South Coast Air Quality Management District

November 14, 2012

Recirculated Draft Environmental Impact Report Southern California International Gateway (SCIG) Project

Attachment A
Additional Comments on the Recirculated DEIR for
Southern California International Gateway (SCIG) Project

Locomotive Peak Daily Emissions

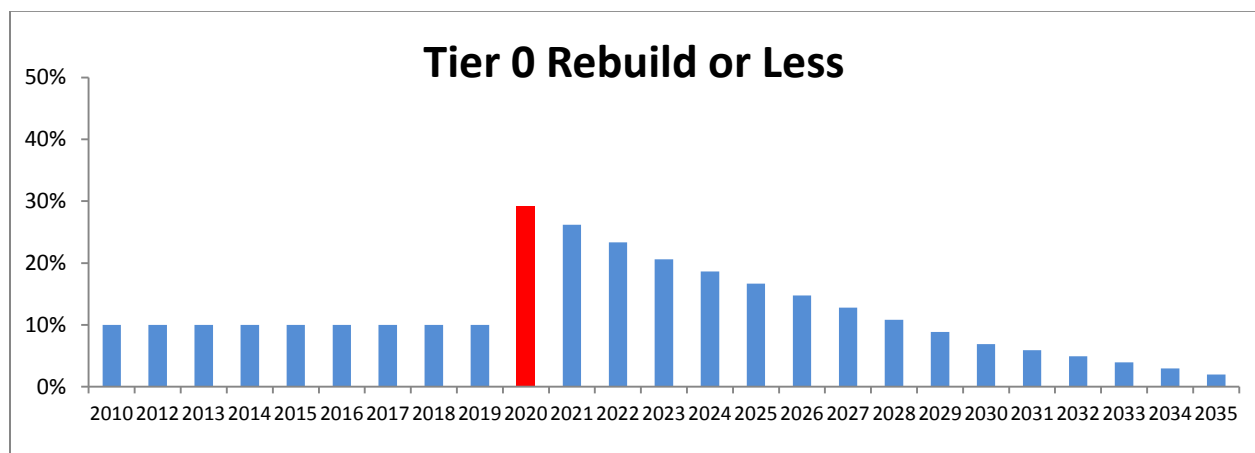
The Recirculated DEIR contains insufficient information for the public to determine the reasonableness of the locomotive peaking factor used to calculate peak day locomotive emissions. In the Draft EIR, peak day locomotive emissions were estimated assuming that all daily locomotive trips on the peak day were conducted by the lowest Tier level locomotive in the fleet mix for each analysis year. The AQMD staff did not comment on this approach because it was conservative, in that it produced locomotive emissions based on the highest emission rate available in the projected fleet. However in the Recirculated DEIR, peak day locomotion emissions were determined by applying a peaking factor to all future year locomotive emission factors. The peaking factor used in the Recirculated DEIR has substantial impacts on the locomotive emissions reported for the proposed Project. For instance, the 2035 NO_x emissions for the proposed Project in the Recirculated DEIR and Draft EIR were 916 pounds per peak day and 3669 pounds per peak day, respectively. This amounts to a 75 percent drop in off-site NO_x locomotive emissions in 2035. The peaking factor used in the Recirculated DEIR was derived by assuming a ratio of the peak day locomotive fleet mix average emissions factor in 2010, to the average day locomotive fleet mix average emissions factor in 2010. No supporting data or information is provided in the Recirculated DEIR on the underlying assumptions that went into deriving the peaking factor. As a result, the AQMD staff is unable to verify that the peaking factor is reasonable.

The application of the peaking factor to future locomotive emission rates further exacerbates the belief of AQMD staff that future locomotive fleet mixes, assumed in the emission rates tables of Appendix C1.2-21 and C1.2-22, over-predict the penetration of Tier 4 locomotives in milestone years 2023 and 2035. When coupled with the peaking factor, it results in an underestimation of the emission rates (and therefore emissions) for the peak day scenario. The approach used in the Draft EIR avoided this problem somewhat by assuming that the peak day emission rates were based on the lowest tier (highest emission rate) locomotive making up the fleet in a specific year.
